SUBJECT: *Secret* Forwards "Design Reverification Program," Vols 1 & 2, final assessment rept. Results of program will be presented to NRC in late Oct 1983.

Subject: WNP-2 Design Reverification Program

# WASHINGTON NUCLEAR PLANT 2 DESIGN REVERIFICATION PROGRAM

SAR CHANGE NOTICE

FIGURE  
 3.6-42

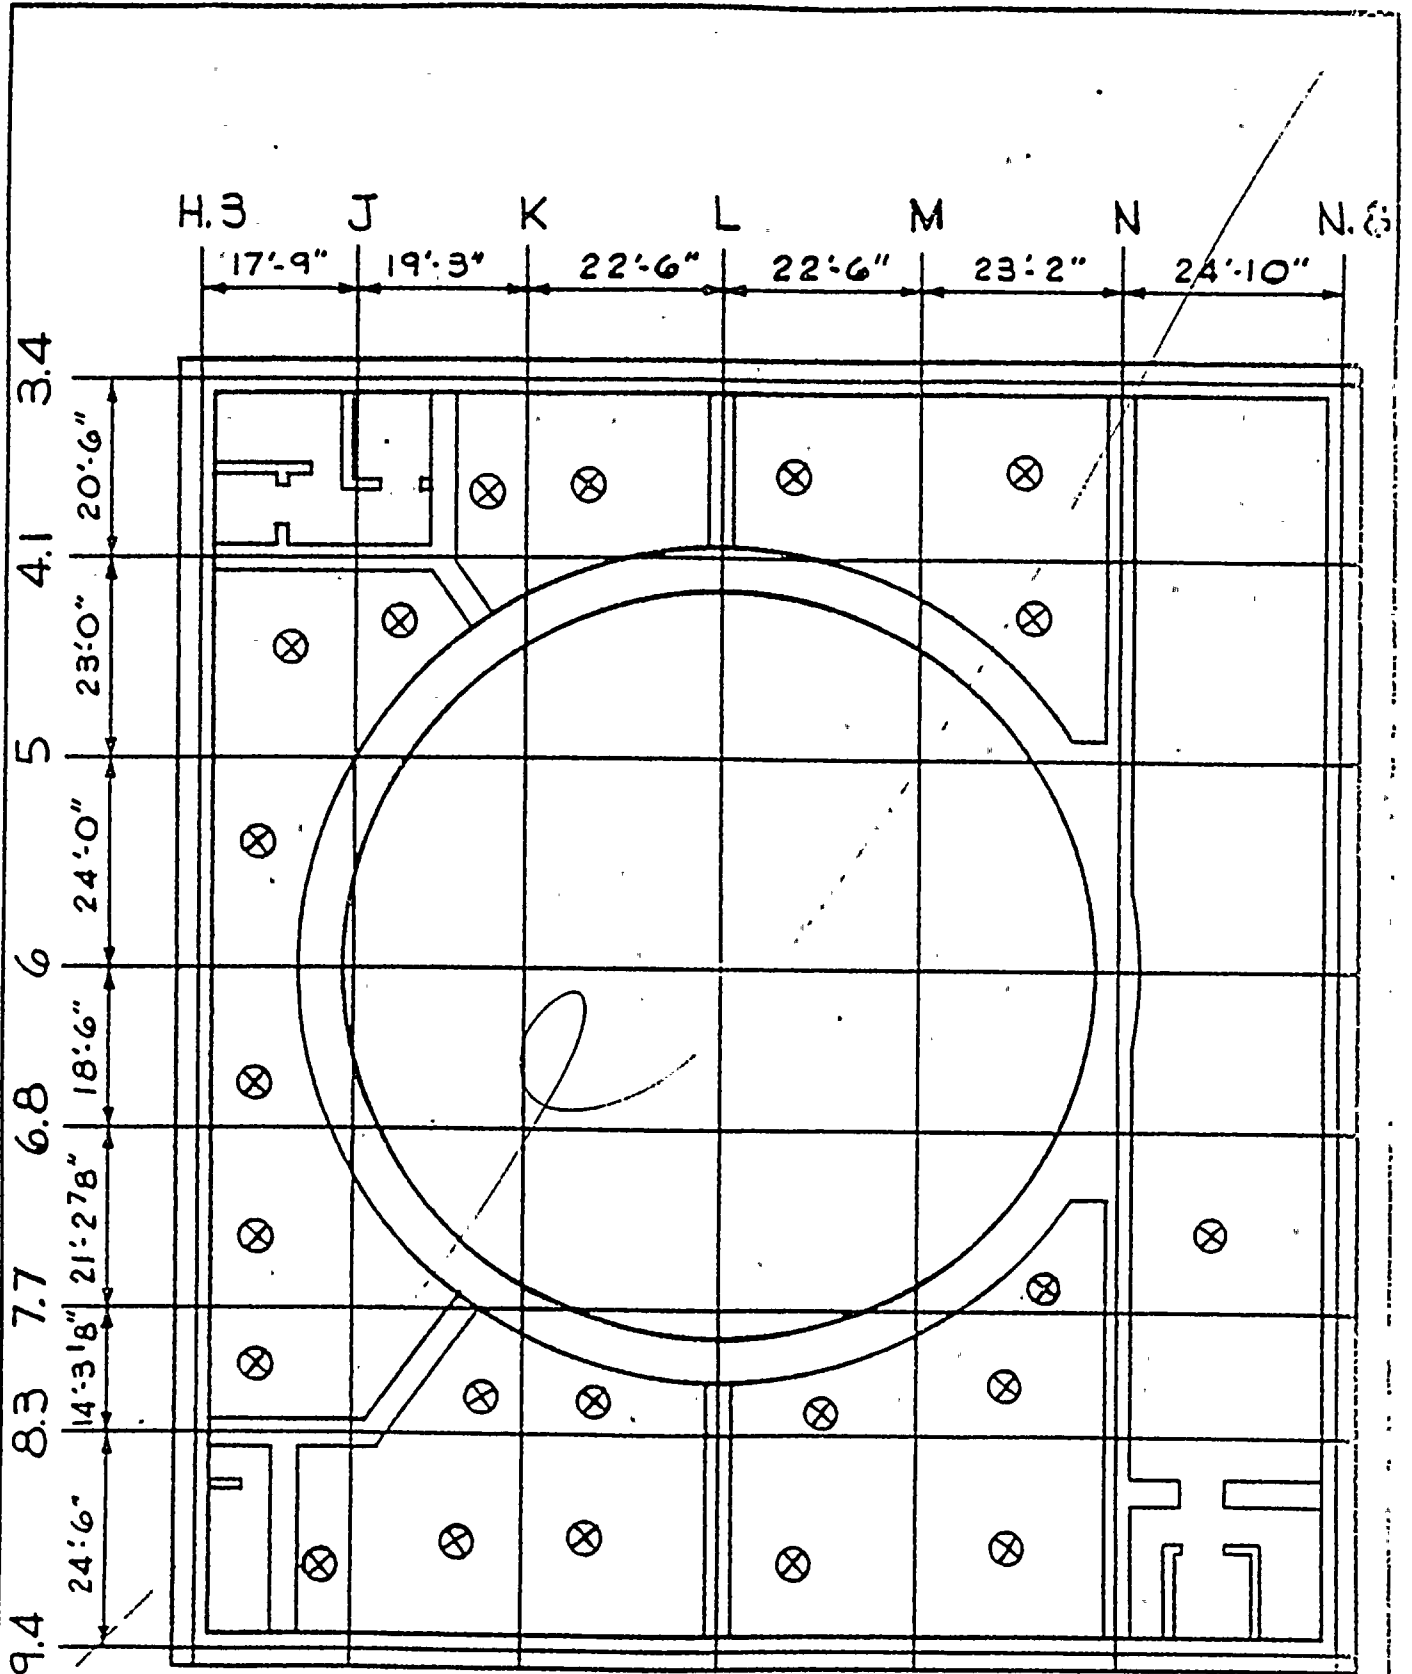
DELETE FIGURE

FIGURE  
 3.6-42

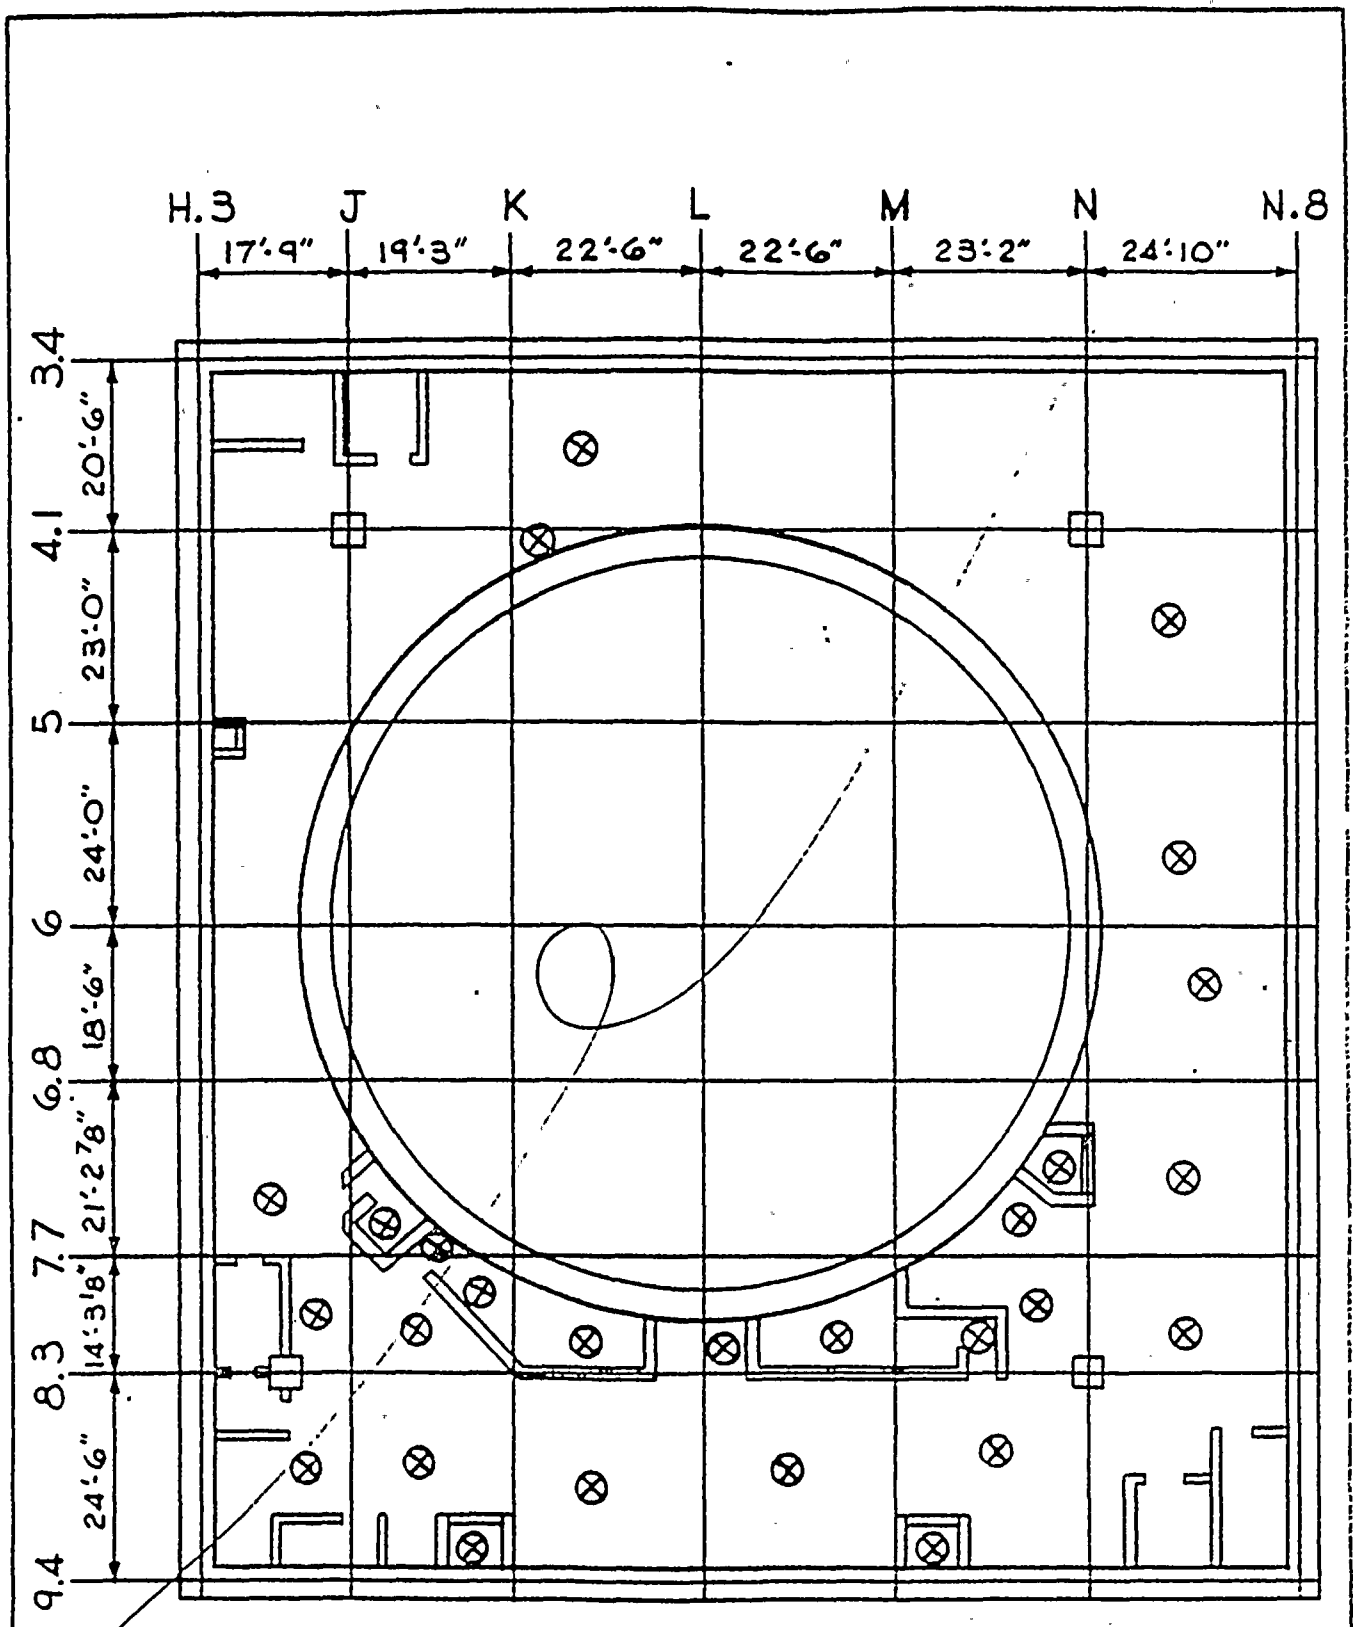
DELETE FIGURE

FIGURE  
 3.6-42c

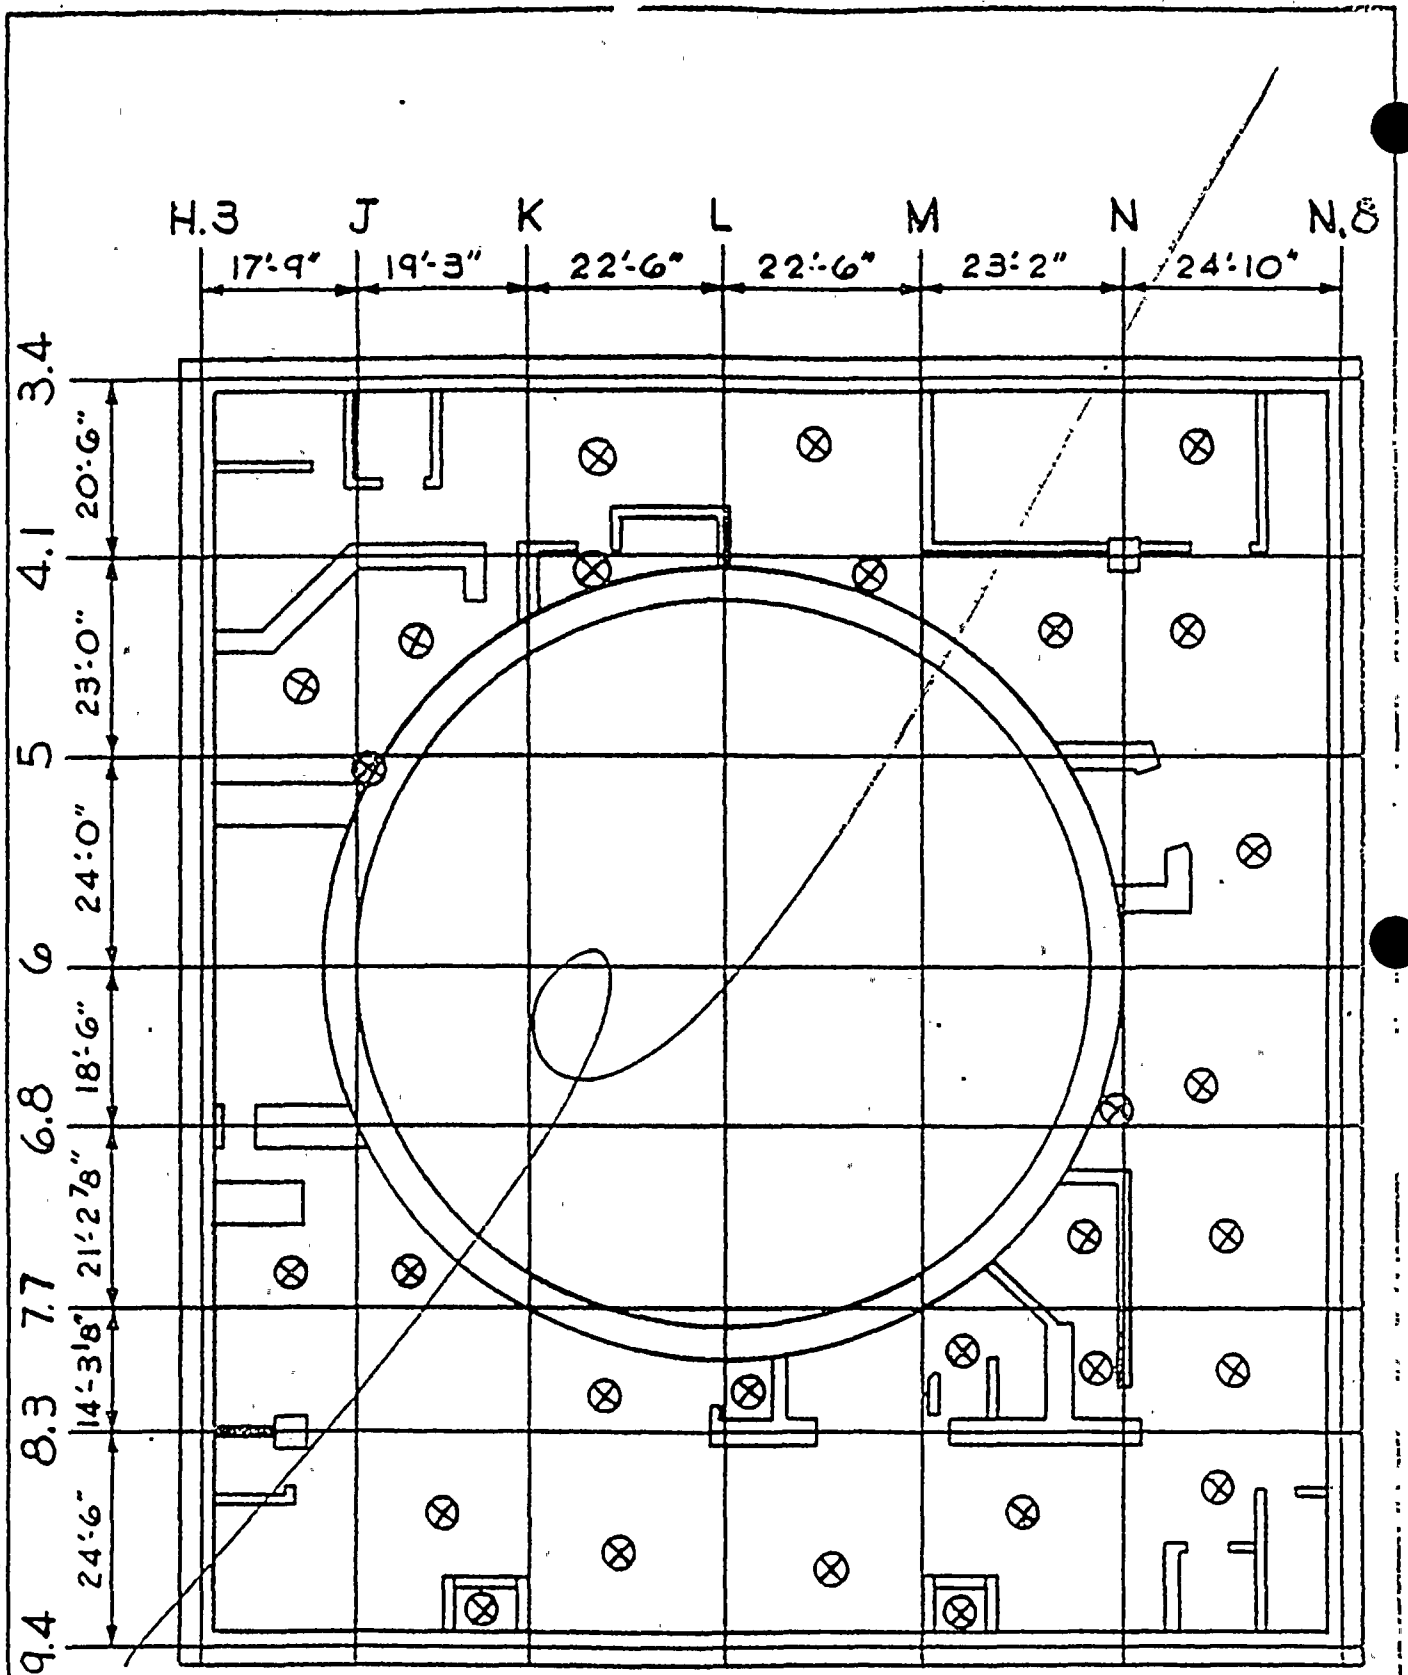
DELETE FIGURE

FIGURE  
 3.6-42

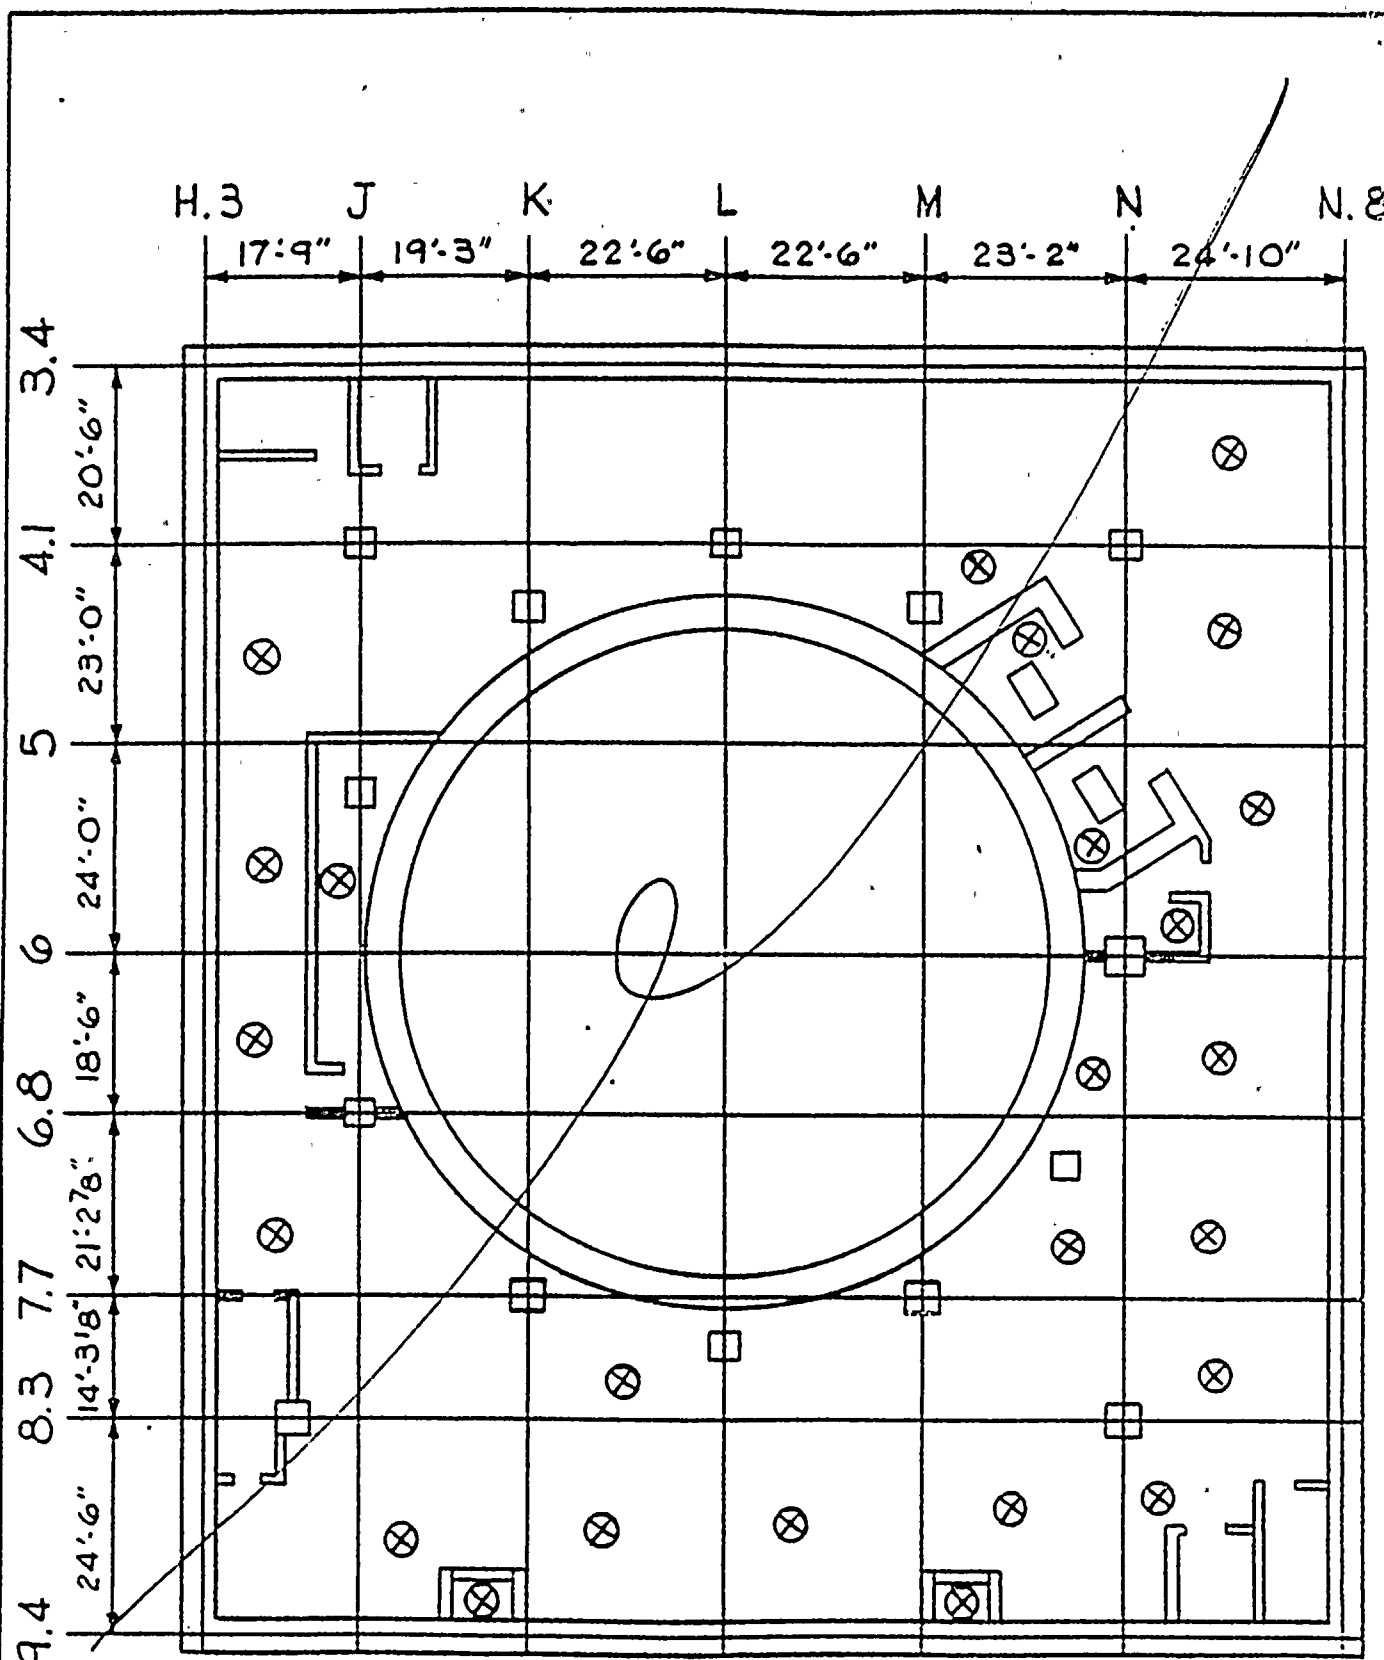
DELETE FIGURE

FIGURE  
 3.6-421

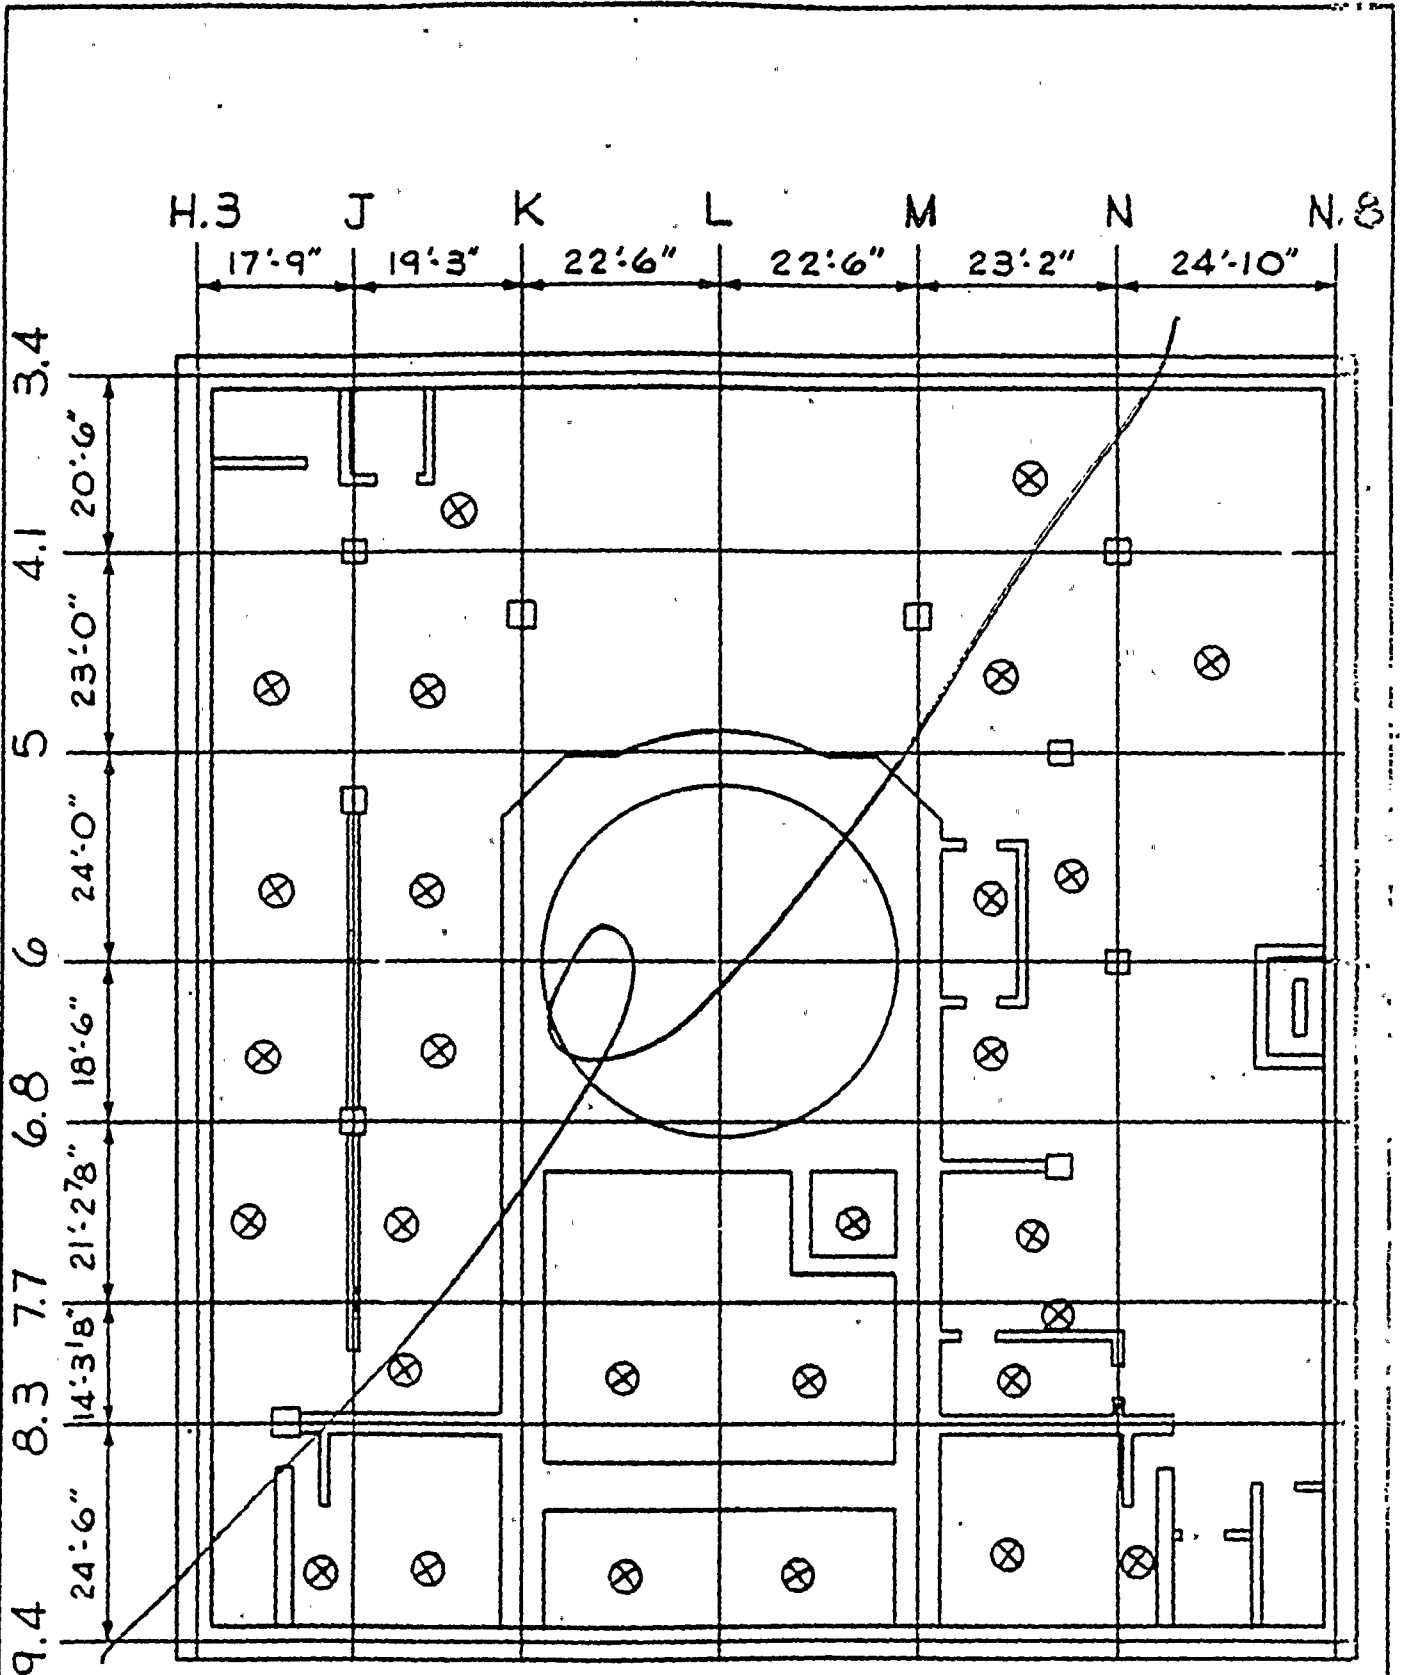
DELETE FIGURE
